EAGLE MOUNTAIN
PLANNING COMMISSION MEETING

FEBRUARY 11, 2025, 5:30 PM
EAGLE MOUNTAIN CITY COUNCIL CHAMBERS
1650 EAST STAGECOACH RUN, EAGLE MOUNTAIN, UTAH 84005

EAGLE MOUNTAIN CITY **PLANNING COMMISSION MEETING** **FEBRUARY 11, 2025**
TITLE:	Parkway Fields Subdivision Preliminary Plat H Approval Request
ITEM TYPE:	Preliminary Plat
FISCAL IMPACT:	n/a
APPLICANT:	Flagship Homes, Luke McColm representing

EAGLE MOUNTAIN CITY **PLANNING COMMISSION MEETING** **FEBRUARY 11, 2025**
TITLE:	Pinnacles B-3 project - Master Site Plan and Preliminary Plat
ITEM TYPE:	Master Site Plan
FISCAL IMPACT:	n/a
APPLICANT:	Century Communities; Toby Cordova representing

PLANT SCHEDULE

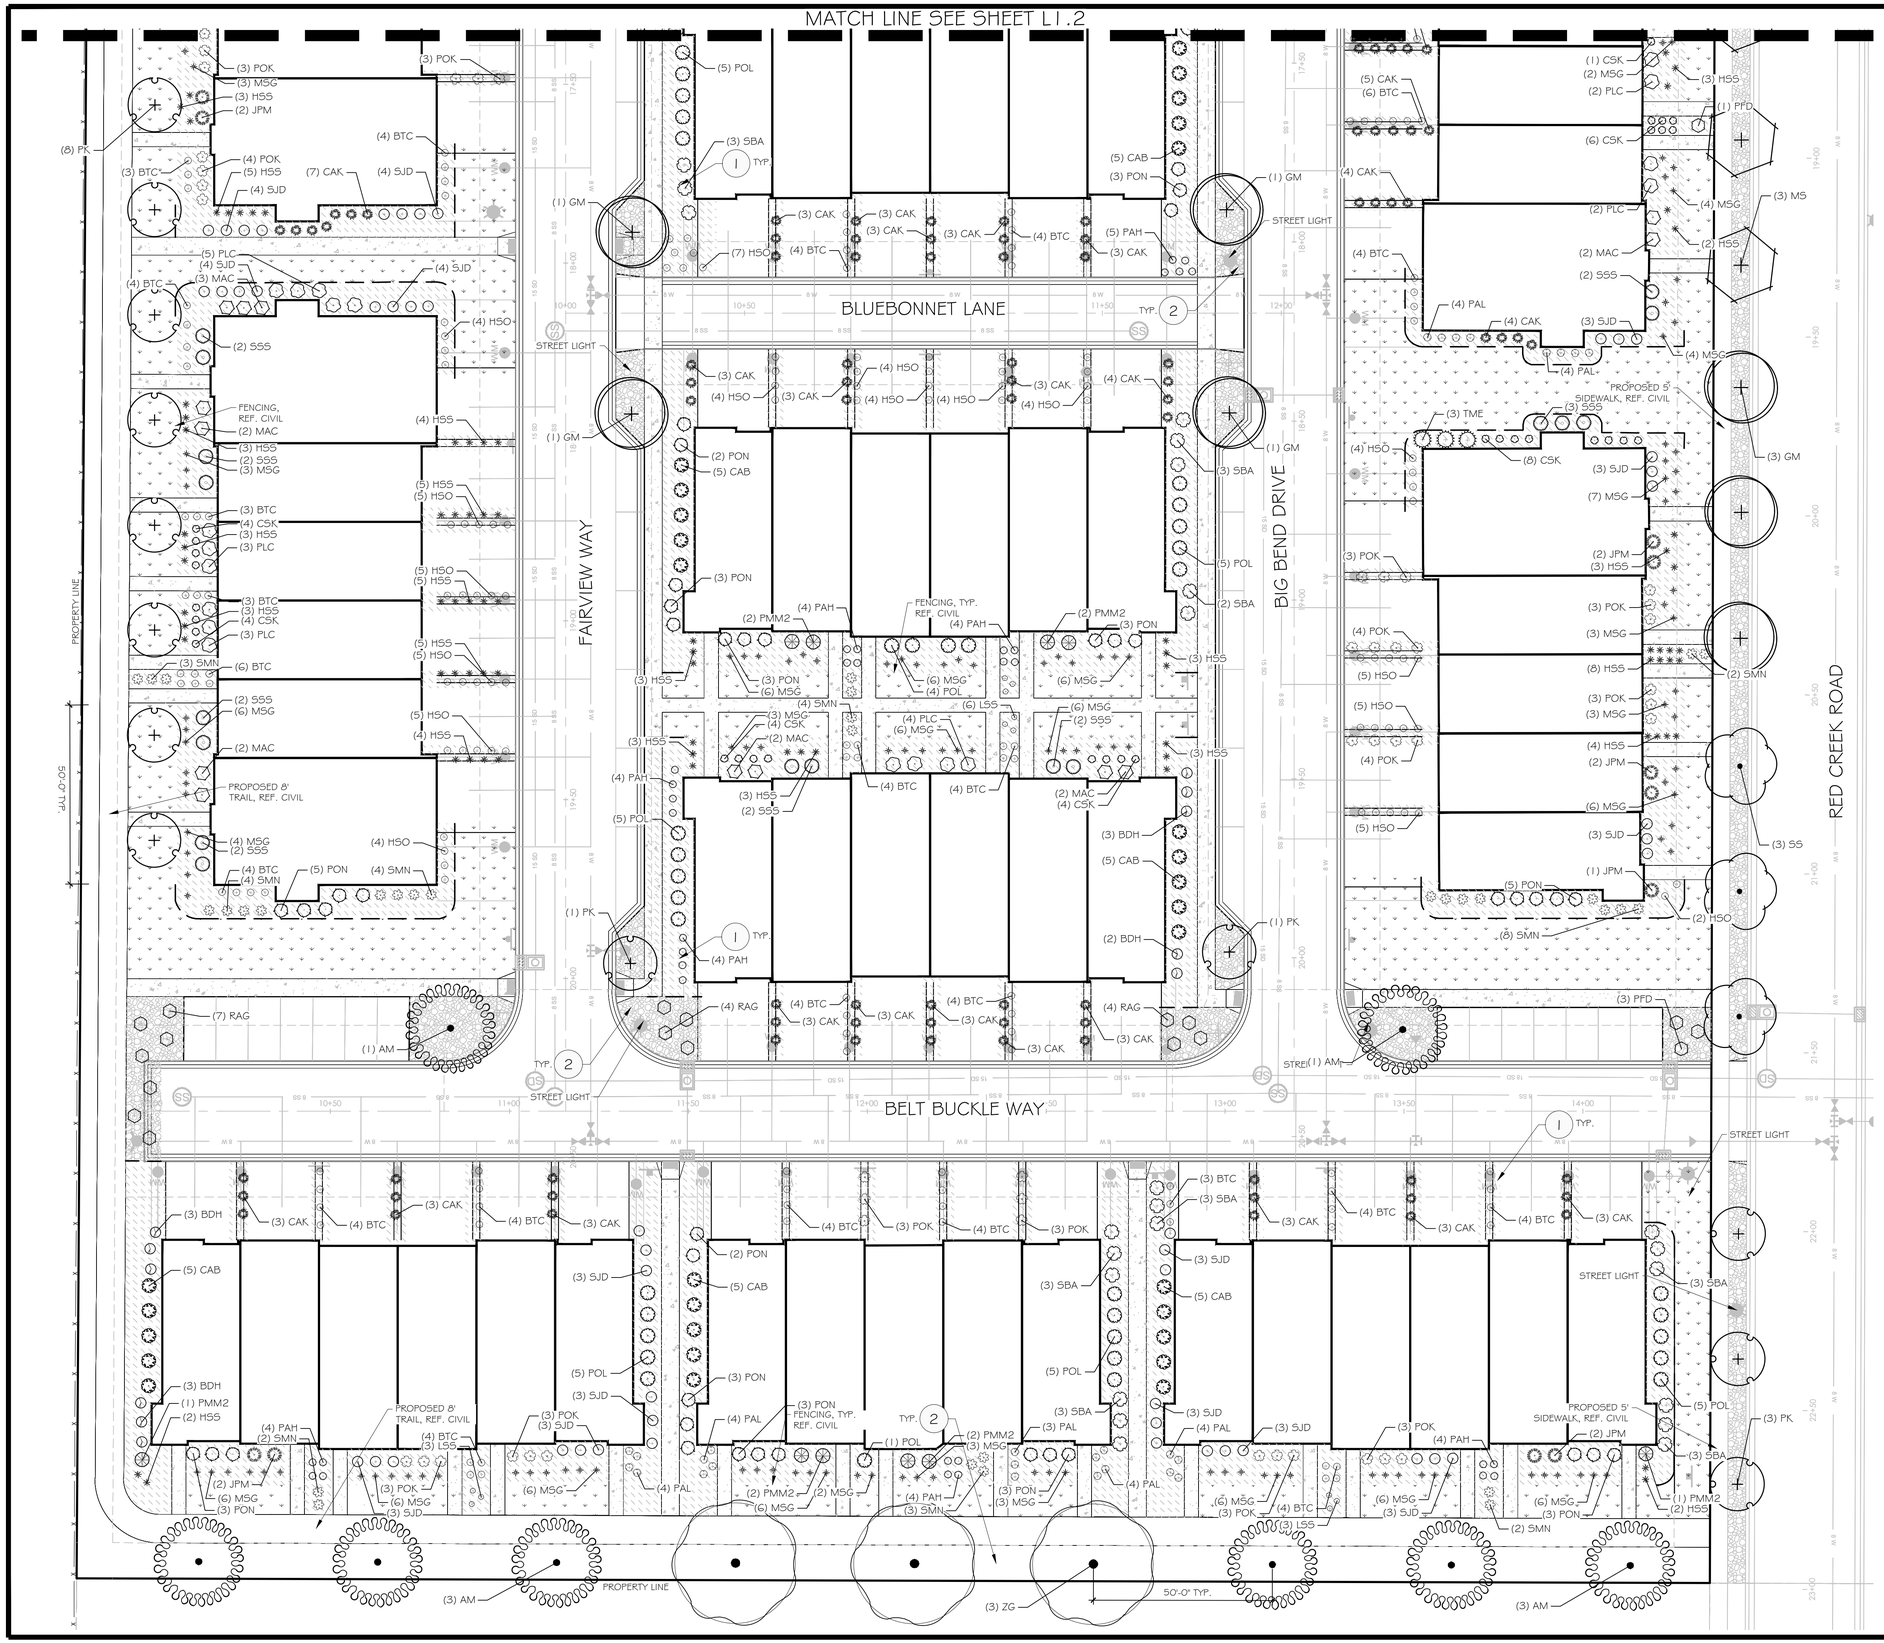
7. Demonstration that at least 594 open space amenity points as per EMMC 16.35.100.B. are achieved by provision of amenities listed in EMMC Table 16.35.130(c). Amenities shall be illustrated and labeled on (the) landscape plan(s) if not already, and a separate document shall be provided to City Staff outlining amenity point compliance.

8. All plan page revisions/corrections listed in Conditions 1-7 above shall be provided on a revised set of plan drawings to be provided to the City prior to the Master Site Plan being presented to the City Council and shall be made part of the requirements of the project's development/build-out.

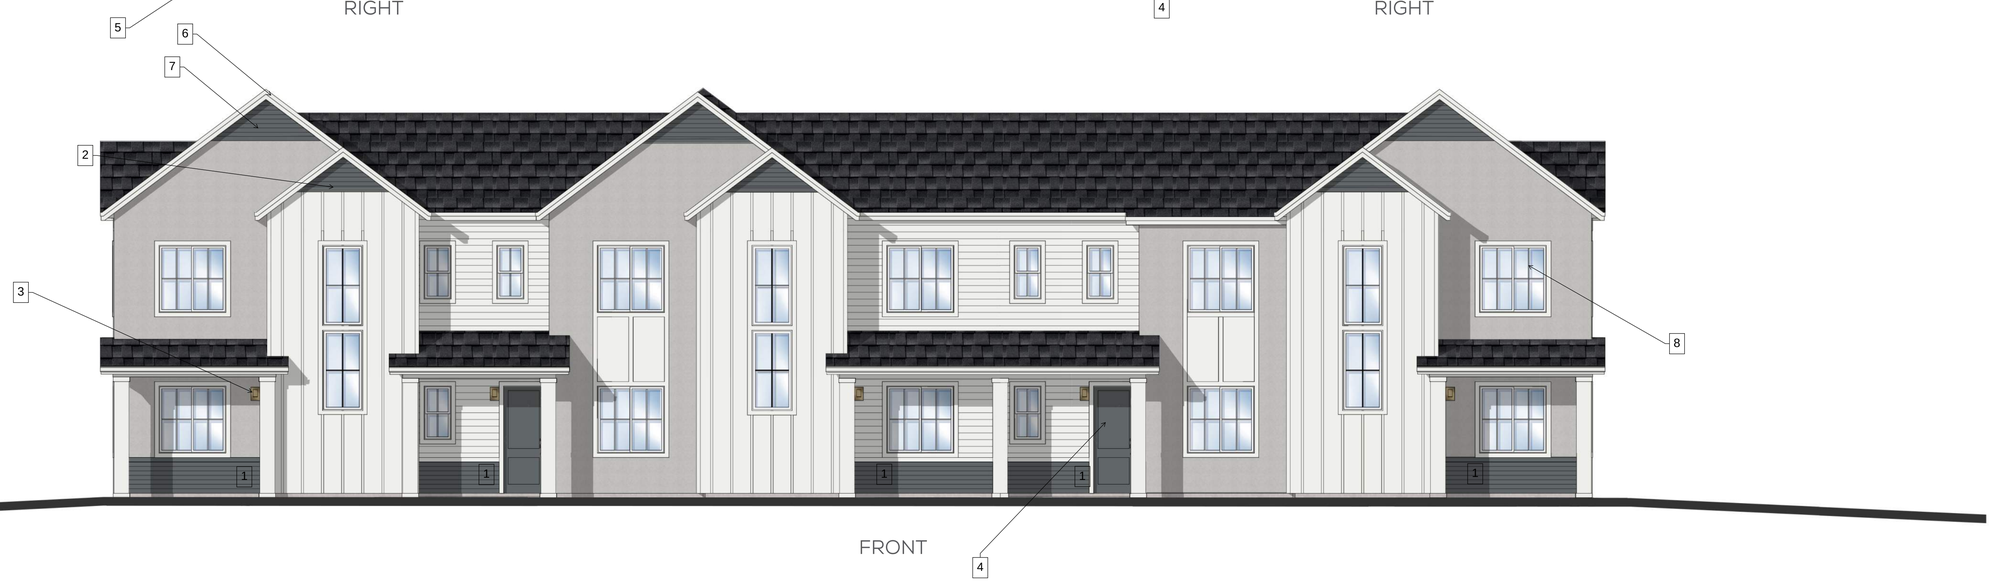
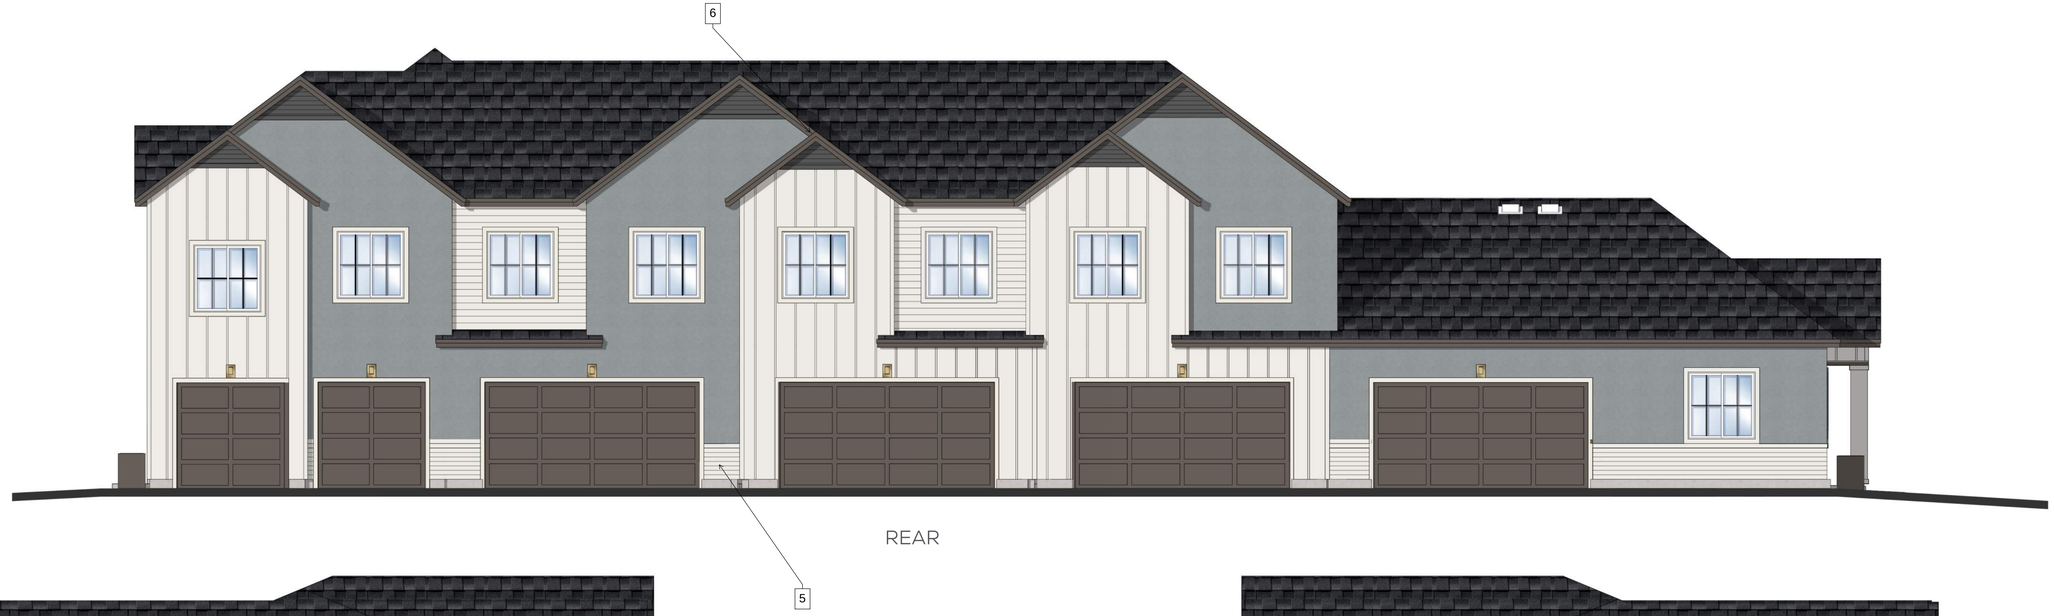
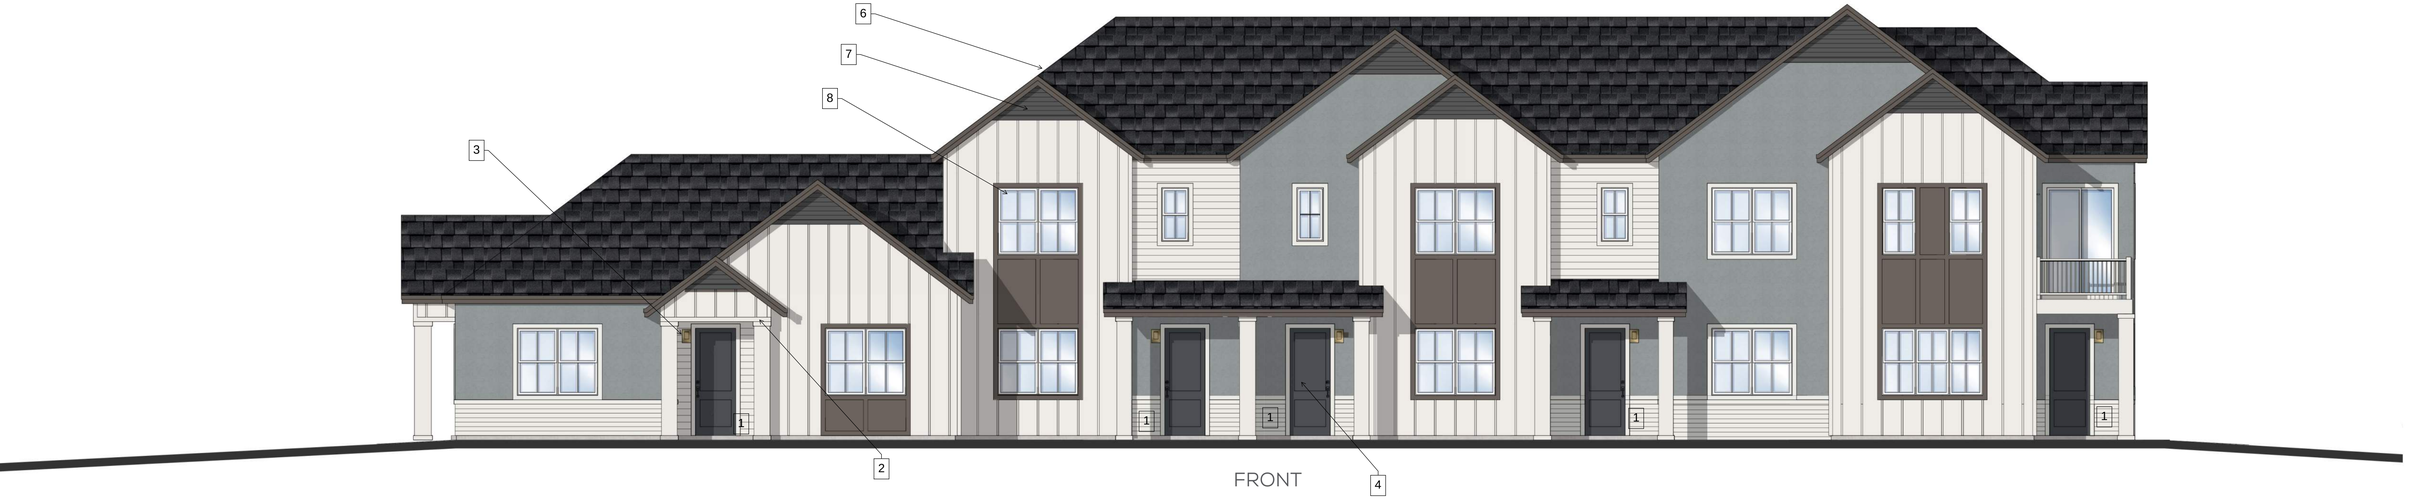
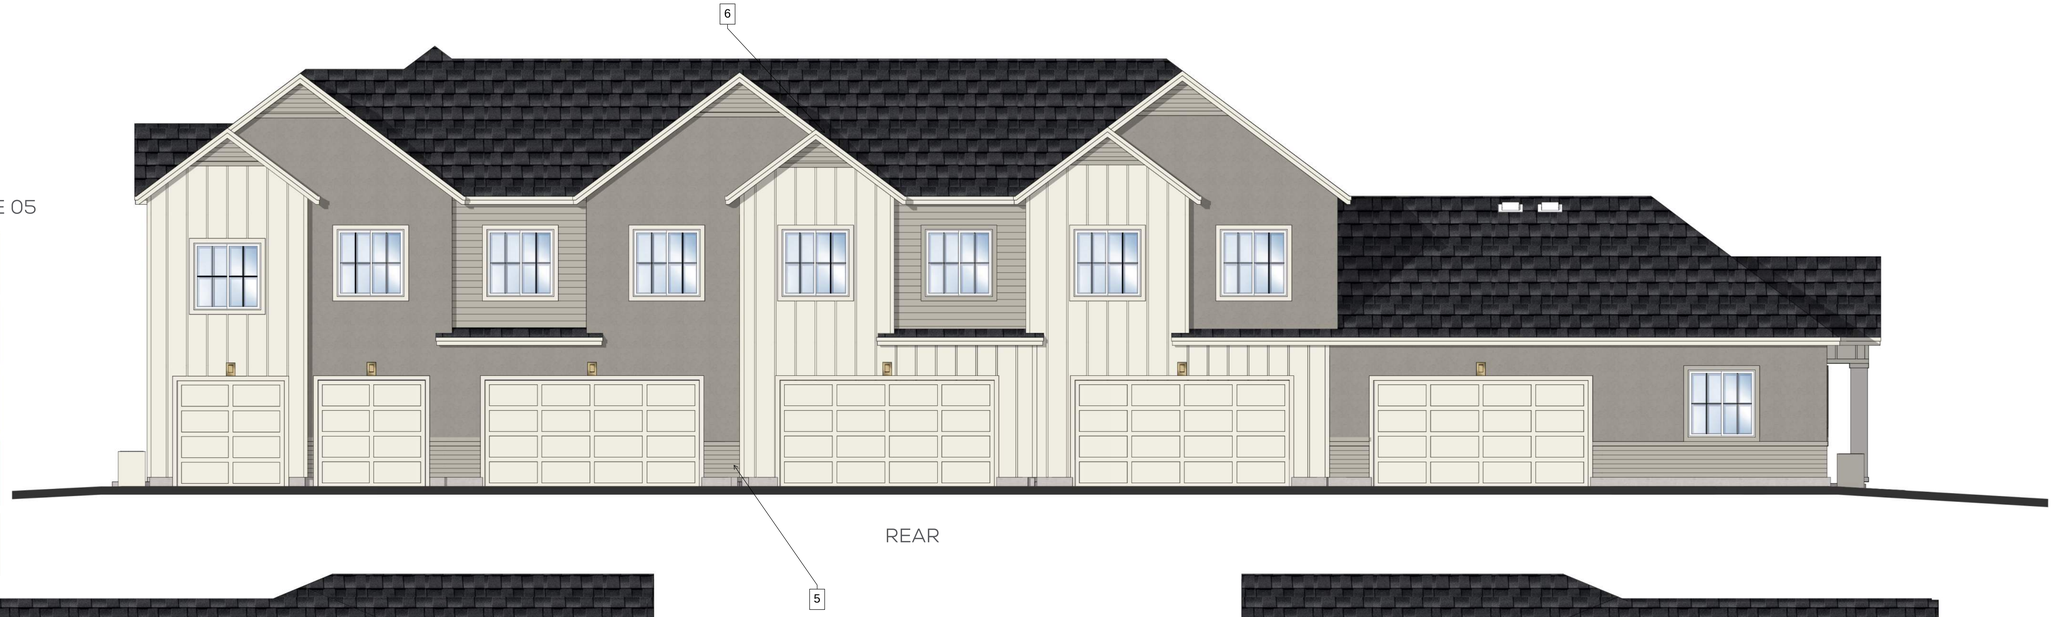
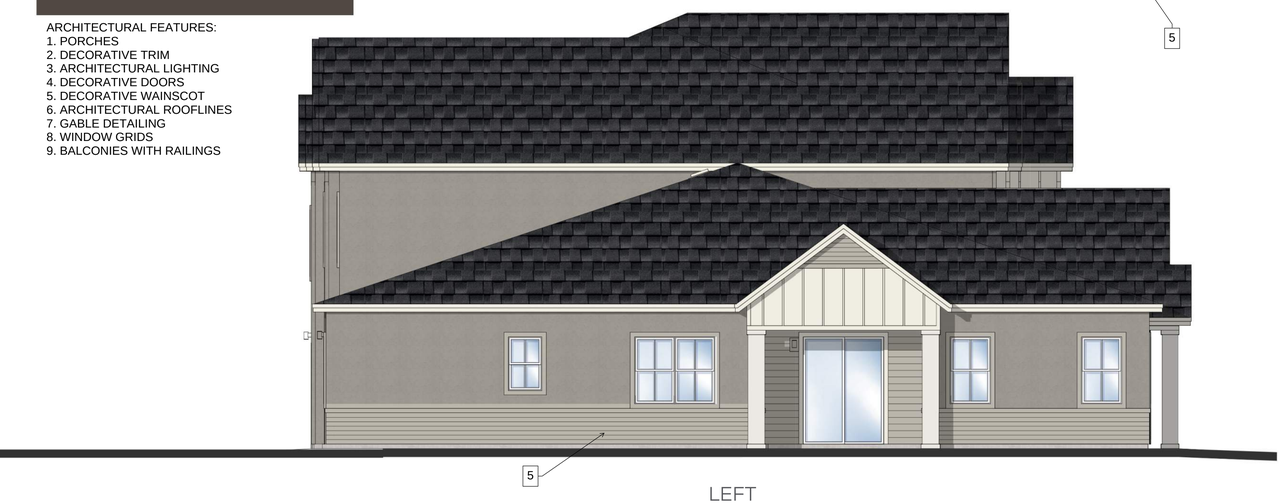
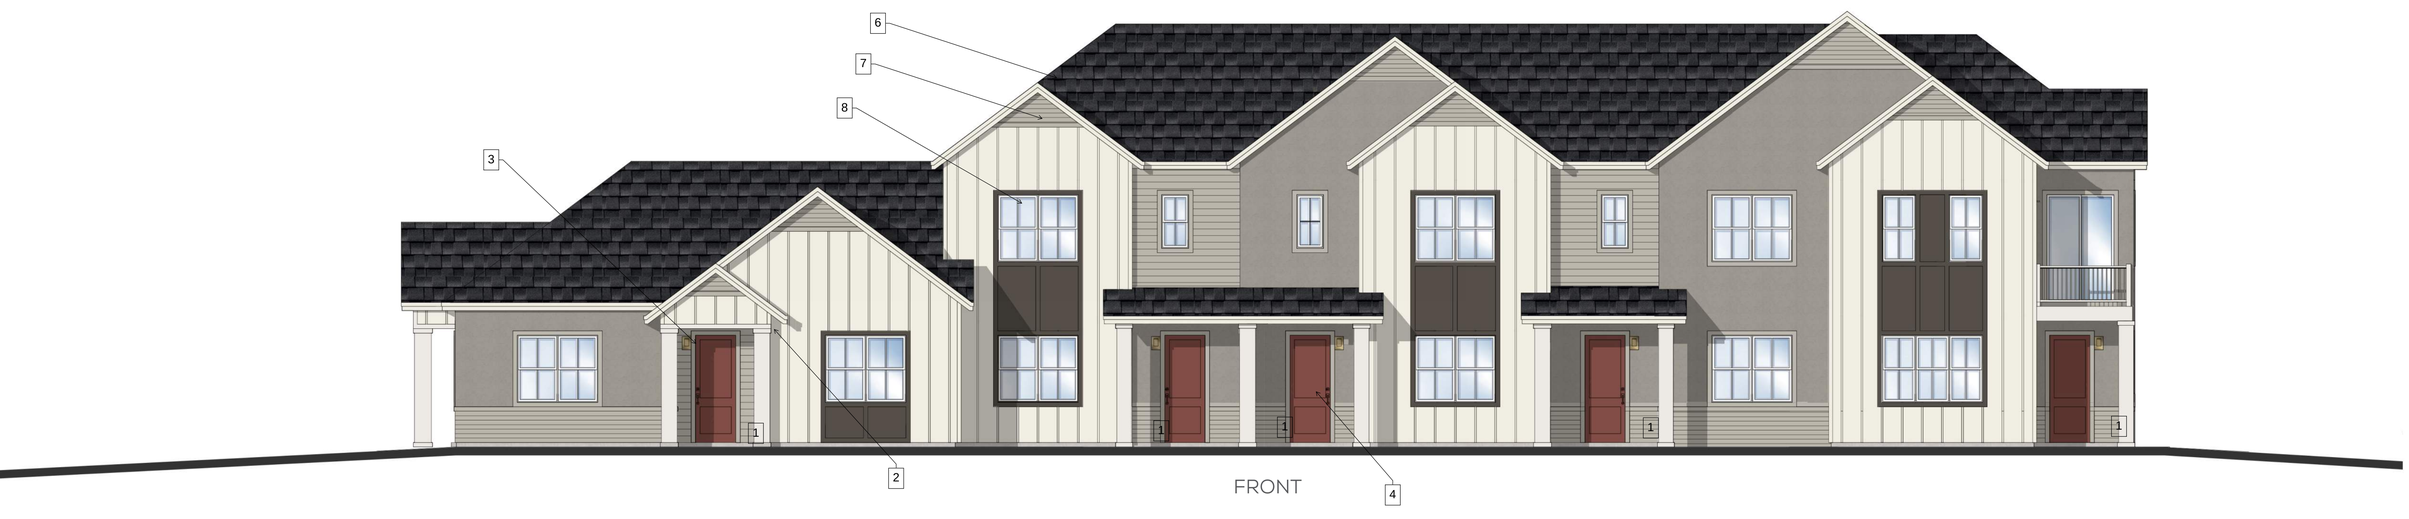
1. Inclusion of at least five (5) additional architectural features/elements chosen from the City approved list in EMMC § 17.72.040.E.2. on the project's "Scheme 07" 4-plexes' plans shall be provided; and,

2. Additional 2nd materials-type coverage (e.g., cementitious fiberboard) on the 4-plex building -- stucco-dominated -- ends shall be provided and illustrated on the project's plans; and,

3. An additional three (3) architectural features/elements chosen from the City approved list in EMMC § 17.72.040.E.2. on the project's "Scheme 10" 5-plexes shall be provided on the project's plans; and,

4. An additional two (2) architectural features/elements chosen from the City approved list in EMMC § 17.72.040.E.2. on the project's "Scheme 04" 5-plexes shall be provided on the project's plans; and,

5. An additional four (4) architectural features/elements chosen from the City approved list in EMMC § 17.72.040.E.2. on the project's "Scheme 06" 6-plexes shall be provided on the project's plans; and,

6. An additional four (4) architectural features/elements chosen from the City approved list in EMMC § 17.72.040.E.2. on the project's "Scheme 07" 6-plexes shall be provided on the project's plans; and,
